Stabilizer Jacks – Too Short

Bulletin Type:	PIN	Publication Date:	February 2020
Bulletin #(s):	19-005	Make(s):	Starcraft
Job Code #(s):	N/A	Model(s):	Launch Outfitter
Flat Rate(s):	N/A	Model Year(s):	2019

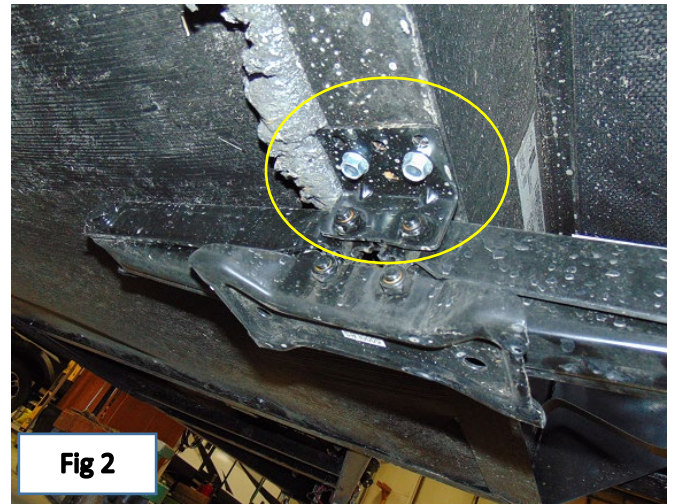
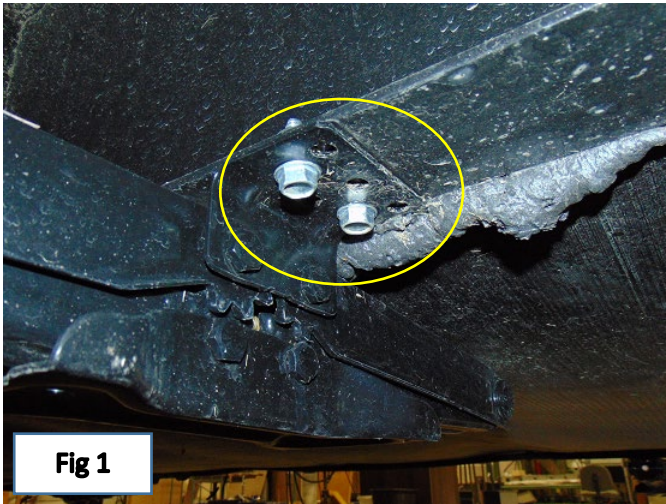
Incident:	Jacks too short, not touching the ground when fully extended.
Affected Units:	31BHS Launch Outfitter Travel Trailer
Parts Kit:	<p>Parts required for 1 Jack:</p> <ul style="list-style-type: none"> • 2 each of part # 2002055 (Jack Spacer Bracket) • 4 each of Part #: 0216363 (3/8" Bolt) • 4 each of Part #: 0216365 (3/8" Thread cutting bolt) • 8 each of Part #: 0011774 (3/8" lock washer) • 8 each of Part #: 0216364 (3/8" nut)
Misc. Tools & Supplies:

Step 1. Remove existing bolts securing the scissor jack at the front of the trailer (Fig.1) and the rear of the trailer (Fig.2). DISCARD BOLTS, NUTS.

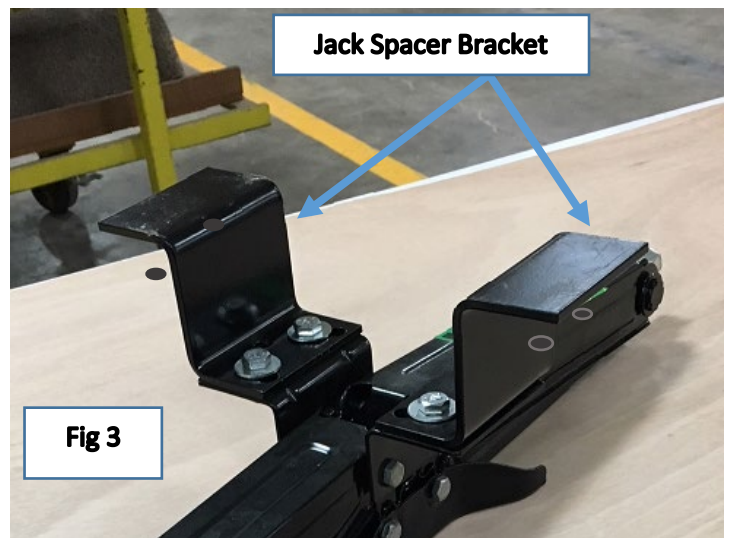
Step 2. Secure the new Jack spacer brackets (Fig.3) in the orientation shown to the removed scissor jack. Use the 3/8" Bolts, Nuts and Lock washers provided.

The addition of the Jack spacer brackets will extend the scissor jack downward, allowing the jack plate to touch the ground.

Note: The larger holes in the Spacer Bracket are for securing the Spacer Bracket to the Jack, the smaller holes are for securing the jack to the trailer frame with the 3/8" Thread cutting bolts, nuts and lock washers. See Step 3.

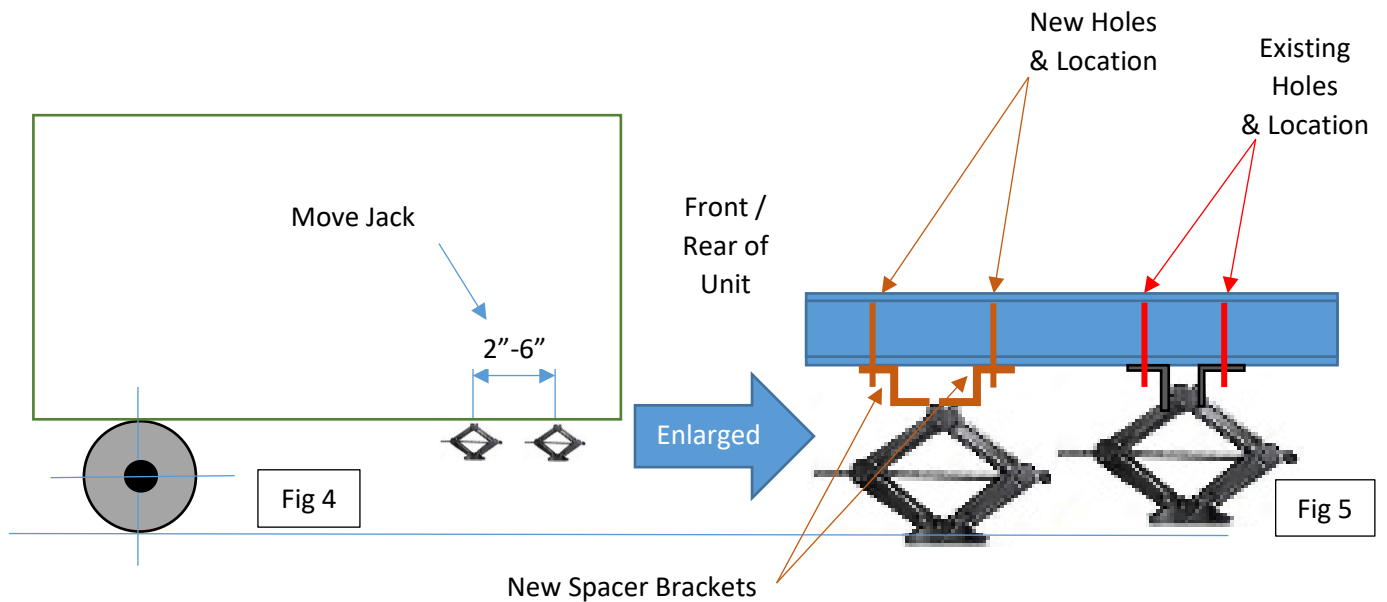
Locate and install the scissor jacks to the frame with the new Spacer Brackets attached (2" to 6") (toward the axles) as shown in (Fig. 4 & 5).

Locate and install the scissor jacks to the frame with the new Spacer Brackets attached (2" to 6") (toward the axles) as shown in (Fig. 4 & 5).

Secure the jacks with the 3/8" Thread cutting bolts, lock washers and nuts provided.

Secure the jacks with the 3/8" Thread cutting bolts, lock washers and nuts provided.
